RECORD DRAWINGS

TREATMENT PLANT ELECTRICAL PLAN

CONTRACT "B"
WELLS AND TREATMENT FACILITIES
ELECTRICAL PLAN AND DETAILS
ELROD WATER COMPANY, INC.
DIVISION "E"
WATERWORKS SYSTEM IMPROVEMENTS

SHEET B16
OF 19

ELEVATION - NORTH WALL ELECTRICAL ROOM

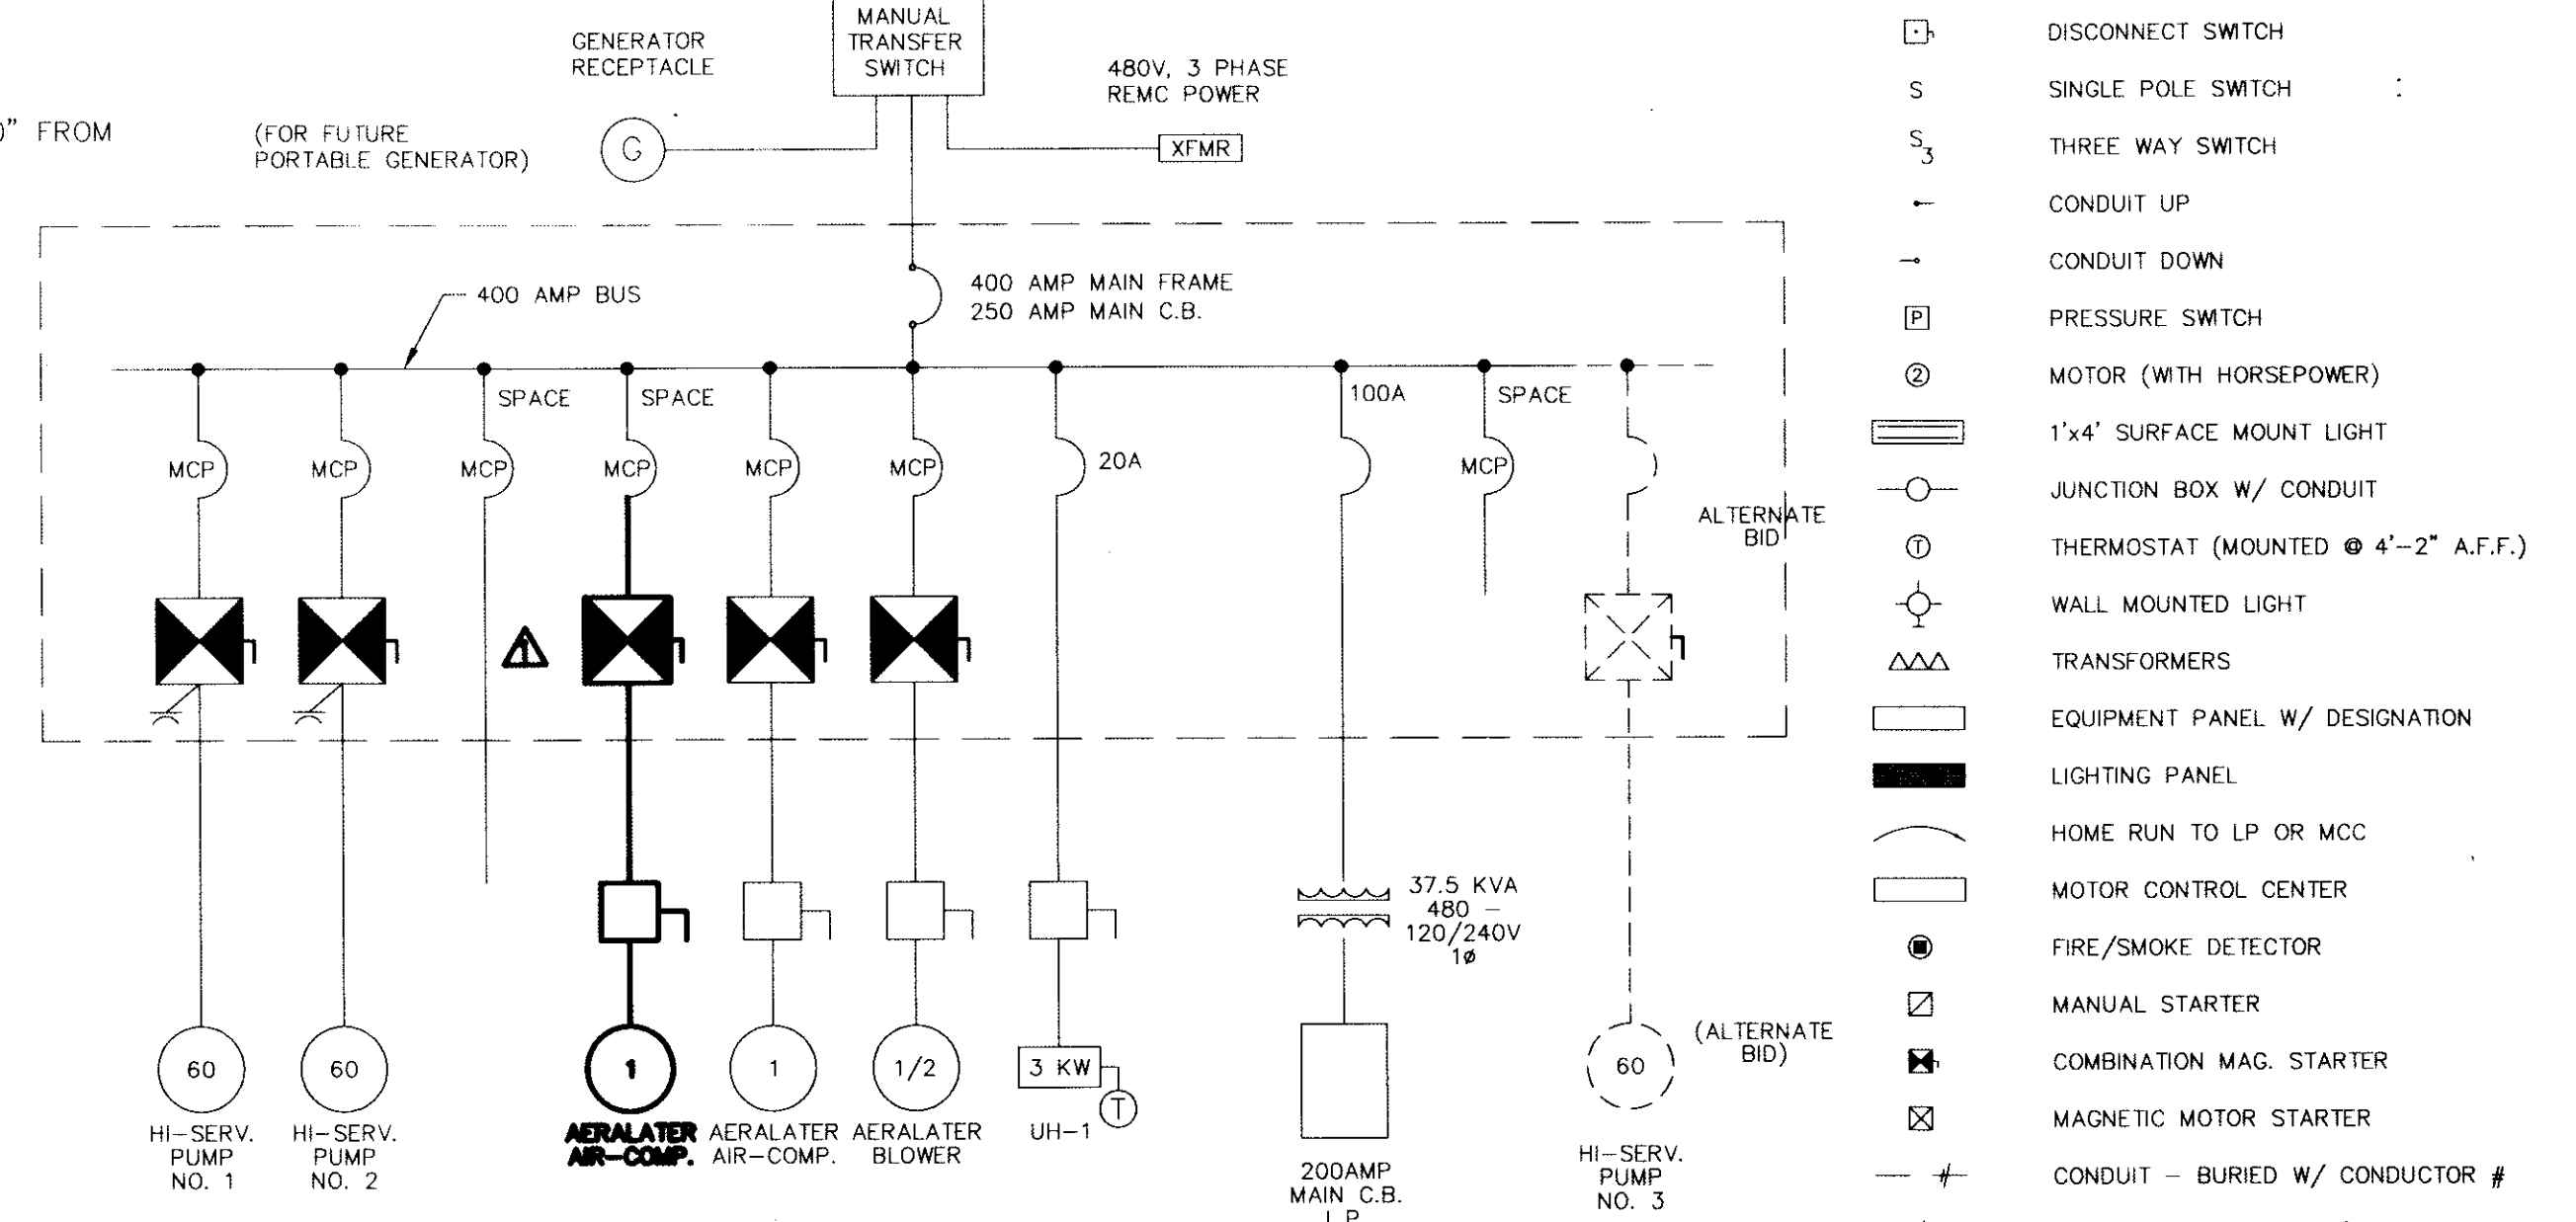
MANUAL TRANSFER SWITCH/MOTOR CONTROL CENTER REARRANGED PER C.O. #2 REFER TO SHEET B10A.
